A long-term dataset of debris-flow and hydrometeorological observations from 1961 to 2024 at Jiangjia Ravine, China, [Paper # essd-2025-190]

Reply to reviewers' comments

Figure 4. (c)illustration of flow depth

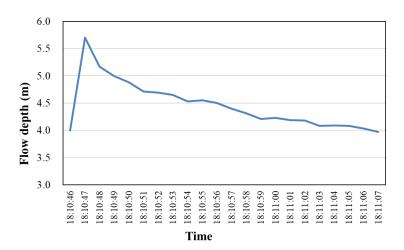
C3: Figure 4: I would add the channel bed to panel c. Is flow depth H+h or only H?

R3: The flow depth is H. According to your suggestion, we added the channel bed to the figure as follows

Figure 6. (a) Variation of flow depth, velocity and (b) discharge, volume of debris-flow surges occurred on July 16th, 1999.

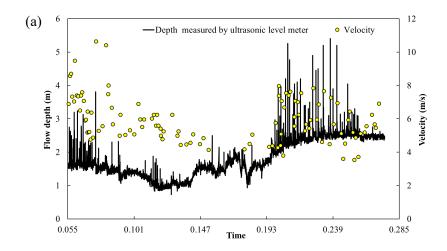
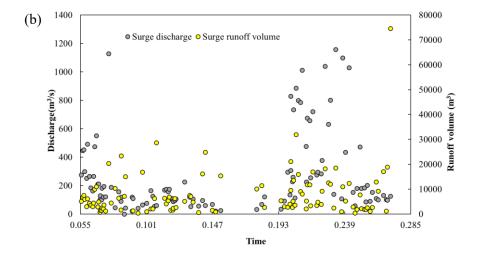
C9: Figure 6: consider using other colors because in the previous figures you use these to differentiate surge types

R9: Thank you for your suggestion. We have redrawn the two figures as follows:

Figure 7. Variation of sediment transported by debris flow recorded from 1966 to 2024. * denotes debris flows occurred without observational data.

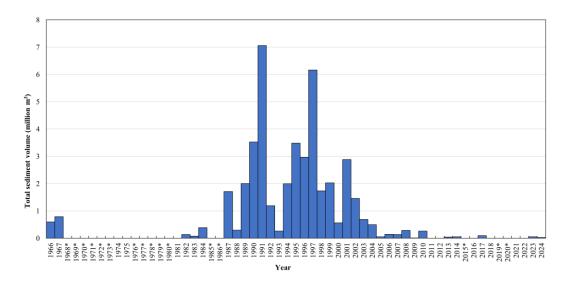
C10: Figure 7: these are huge inter-annual variabilities and the catchment seems inactive now. Is this correct? Can this variability be explained with interruptions of systematic monitoring?

R10: As shown in Figure 3, debris flows indeed occurred in 1968, 1969, 1970, 1971, 1972, 1973, 1976, 1977, 1978, 1979, 1980, 1985, 1986, 2015, 2019, and 2020. However, in these years, the debris flows did not reach the monitoring section, resulting in no observational data (these years are also annotated in Figure 7). Partial surge data are missing for the events in 1974 and 1975, and no total sediment transport data is available for these years.

Overall, the frequency and magnitude of debris flows have significantly declined in recent decades. However, the events in 2023 and 2024 still recorded significant sediment transport volumes of 52,682 m ³ and 31,450 m³, respectively, which remain substantial for mountainous watersheds. By the way, we are currently analyzing the relationship between climate change and sediment transport, to reveal the key factors that control the declined rate of sediment.

We have added the description in the revised manuscript (Page 14, Line 277-280):

"Overall, the frequency and magnitude of debris flows have significantly declined in recent decades. However, the events in 2023 and 2024 still recorded significant sediment transport volumes of 52,682 m ³ and 31,450 m³, respectively, which remain substantial for mountainous watersheds. The decreasing trend may be a result of climate change."

Figure 13. (d) statistical box plot of monthly rainfall at the Mayiping rain gauge (rainfall data are averaged over period 2013-2023). The points above the box plot denote extreme monthly rainfall.

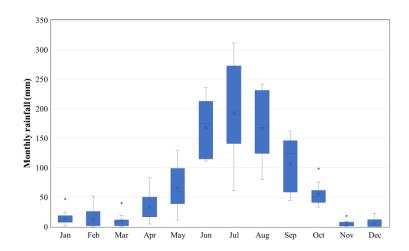
C12: Figure 12d/13/15: I understand that you want to show what your data looks like and this makes sense for data of debris flow events, but I don't think this is very informative for long-term meteo data. I would consider bar plots (like 12a) showing monthly mean and error bars with e.g. min/max values from your observation period.

R12: Long-term time series data would be more informative, but the figures presented in the manuscript only show short-term data. In fact, except rainfall, the meteorological and sediment concentration data in the dataset are relatively limited, making it difficult to construct statistical charts of long time series. Figure 12 has been revised according to your suggestions, and Figure 13b has been removed.

We also added the following description in the manuscript (Page 23, Line 392-395):

"The boxplot Fig. 13d illustrates the distribution of monthly rainfall throughout the year. Rainfall shows obvious seasonality, peaking during the rainy season (June to September) and reaching its lowest levels during the dry season (November to March)."

Figure 7. Variation of sediment transported by debris flow recorded from 1966 to 2024. * denotes debris flows occurred without observational data.

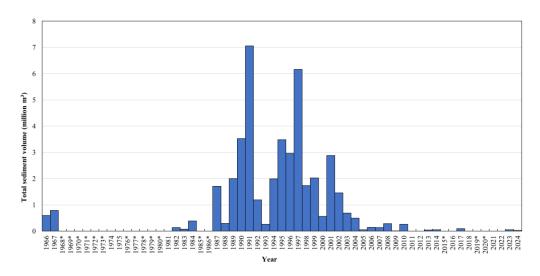
C1: In Figure 7, the sediment transported by debris flow shows considerable inter-annual variability. Could the authors clarify whether this level of variation is consistent with the actual field conditions, and if so, provide a reasonable explanation for these fluctuations?

R1: As shown in Figure 3, debris flows indeed occurred in 1968, 1969, 1970, 1971, 1972, 1973, 1976, 1977, 1978, 1979, 1980, 1985, 1986, 2015, 2019, and 2020. However, in these years, the debris flows did not reach the monitoring section, resulting in no observational data (these years are also annotated in Figure 7). Partial surge data are missing for the events in 1974 and 1975, and no total sediment transport data is available for these years.

Overall, the frequency and magnitude of debris flows have significantly declined in recent decades. However, the events in 2023 and 2024 still recorded significant sediment transport volumes of 52,682 m ³ and 31,450 m³, respectively, which remain substantial for mountainous watersheds. By the way, we are currently analyzing the relationship between climate change and sediment transport, to reveal the key factors that control the declined rate of sediment.

We have added the description in the revised manuscript (Page 14, Line 277-280):

"Overall, the frequency and magnitude of debris flows have significantly declined in recent decades. However, the events in 2023 and 2024 still recorded significant sediment transport volumes of 52,682 m ³ and 31,450 m³, respectively, which remain substantial for mountainous watersheds. The decreasing trend may be a result of climate change."

Figure 8. (b) the time-domain seismic signal and time-frequency characteristic curves of the debrisflow event on July 28th, 2024.

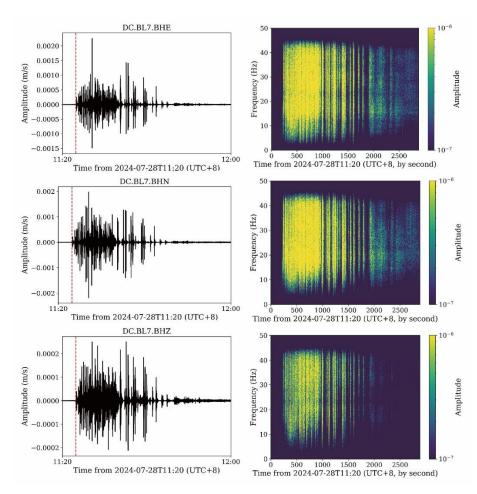
C2: The text in Figures 3 and 8b is difficult to read due to low resolution. It is recommended to improve the image quality and enhance the readability of the labels and annotations in these figures.

R2: Thank you for your suggestion. We have redrawn the figure as follows:

Accuracy validation of air temperature measurements and hourly rainfall measurements

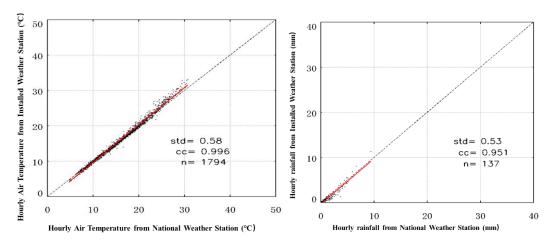
C5: Regarding data reliability, it would strengthen the manuscript if the authors could clarify whether any cross-validation or data consistency checks were performed to verify the validity of the long-term observations.

R5: Most datasets, including debris-flow kinematic data, particle size distribution of debris flows, rheological data of debris-flow slurry, cross-sectional measurement data, sediment concentration, grain size distribution data, and observation data from runoff plots, were obtained through manual observation. These data are considered to have relatively small errors. Additionally, we performed calibration and verification of rain gauges and weather stations in 2021. Some of the results are shown in the following figures, indicating high reliability.

We have added this information in the revised manuscript (Page 27, Line 475-483):

"Most datasets, including debris-flow kinematic data, particle size distribution of debris flows, rheological data of debris-flow slurry, cross-sectional measurement data, sediment concentration, grain size distribution data, and observation data from runoff plots, were obtained through manual observation. These data are considered to have relatively small errors. Additionally, rainfall data from tipping-bucket rain gauges, collected prior to 2024, showed high reliability when cross-validated with data from regional national meteorological stations. In 2024, piezoelectric rain gauges and meteorological stations were installed and underwent performance verification at national benchmark sites before deployment. The correlation coefficients between these instruments and the reference data from national meteorological stations were 0.951 for the piezoelectric rain gauges and 0.996 for the meteorological stations."
